On behalf of the MidBeach Neighborhood Association (MBNA), we would like to express our appreciation to Mr. David Gomez, from the Office of Capital Improvement Projects, and to Paola Vega, Lauren Firtel, Gianni Feoli and Kevin Pulido for attending our MBNA Meeting on April 11th, and providing updates on the Recreational Corridor (or "Beach Walk" as it's commonly known).

1. PALM TREES ON TOP OF PAVERS

2. PAVER DESIGN

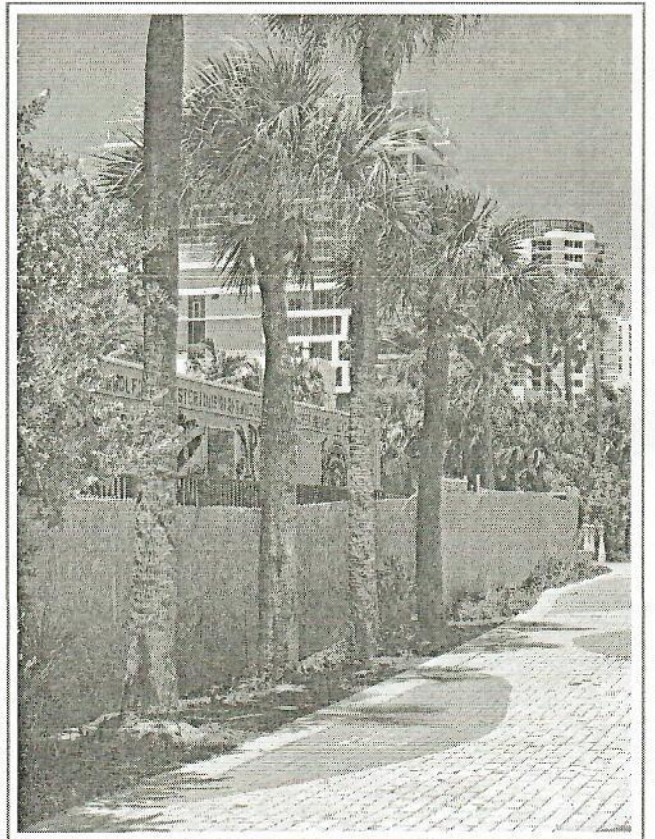
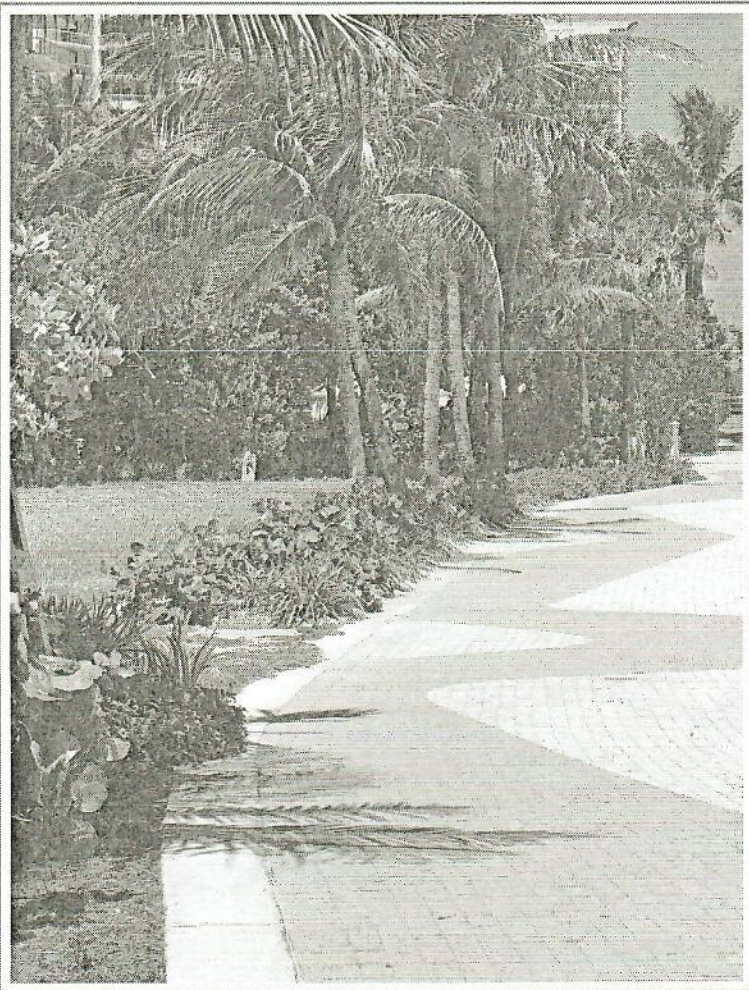
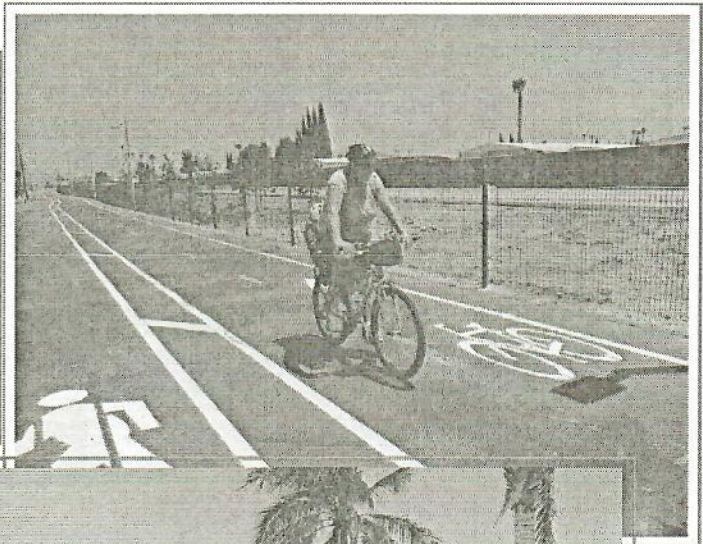
MBNA'S POSITION: Palm trees should be installed to the East (preferably) or West of the pavers. There are numerous examples of this on our current Beach Walk; (*see photo collage on page 3.*)

Palm Trees have been installed on the East and West sides of the Beach Walk in numerous places.

**Beach Walk designs that
create visual separations
for bicycles and
pedestrians**

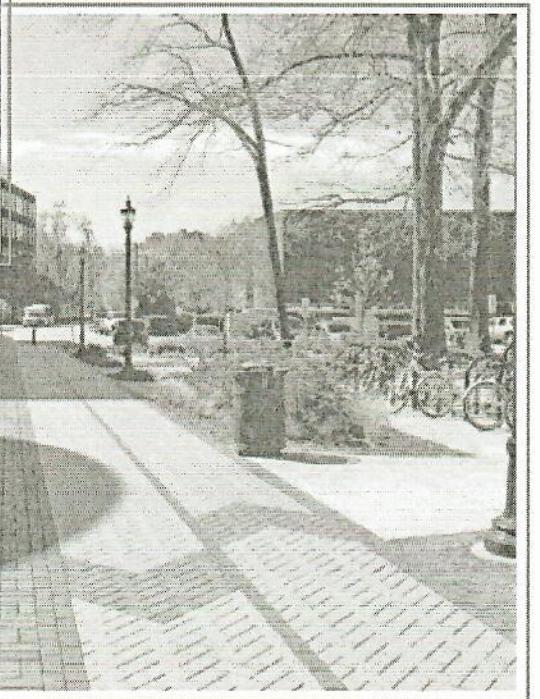
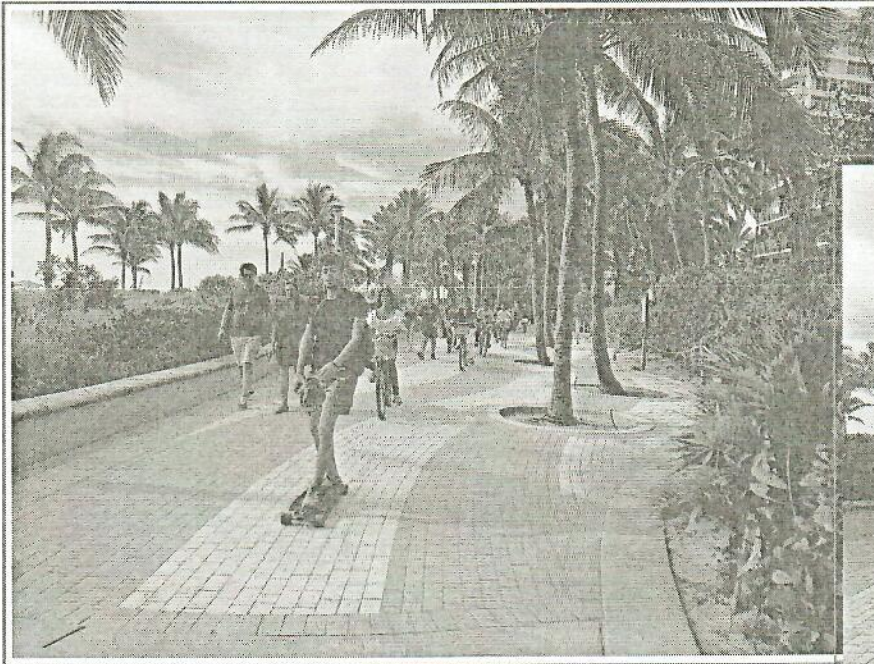
MBNA's POSITION: Pavers should be installed with a design that creates a visual separation between walkers/joggers and bicyclists; (*see photo collage on page 4.*)

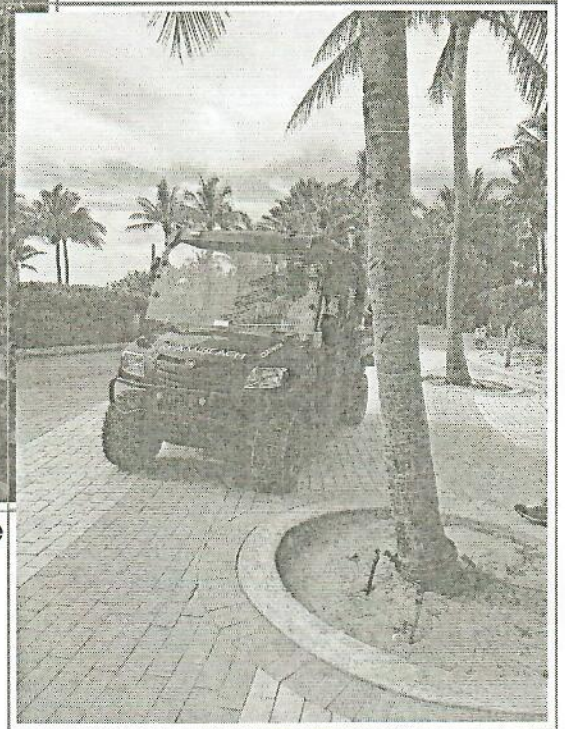
Palm trees are placed only in wide areas. Even here, they're narrowing the Beach Walk and are not providing shade.

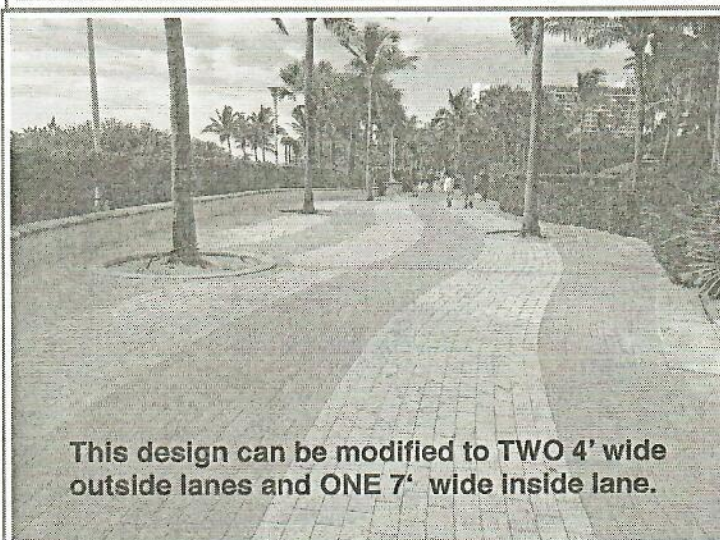
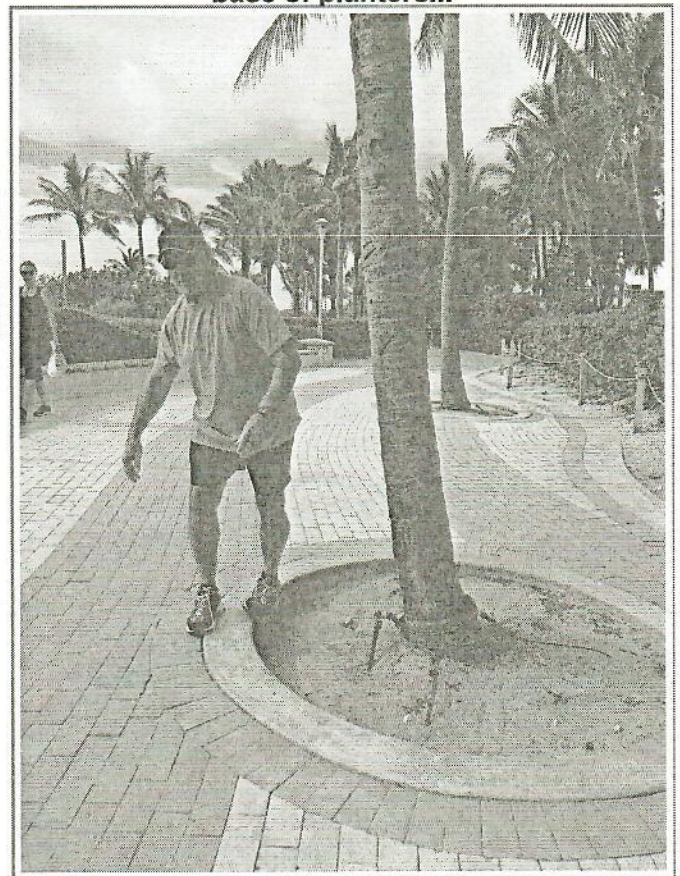
Dangerous tripping hazard at base of planters...

This design can be modified to TWO 4' wide outside lanes and ONE 7' wide inside lane.
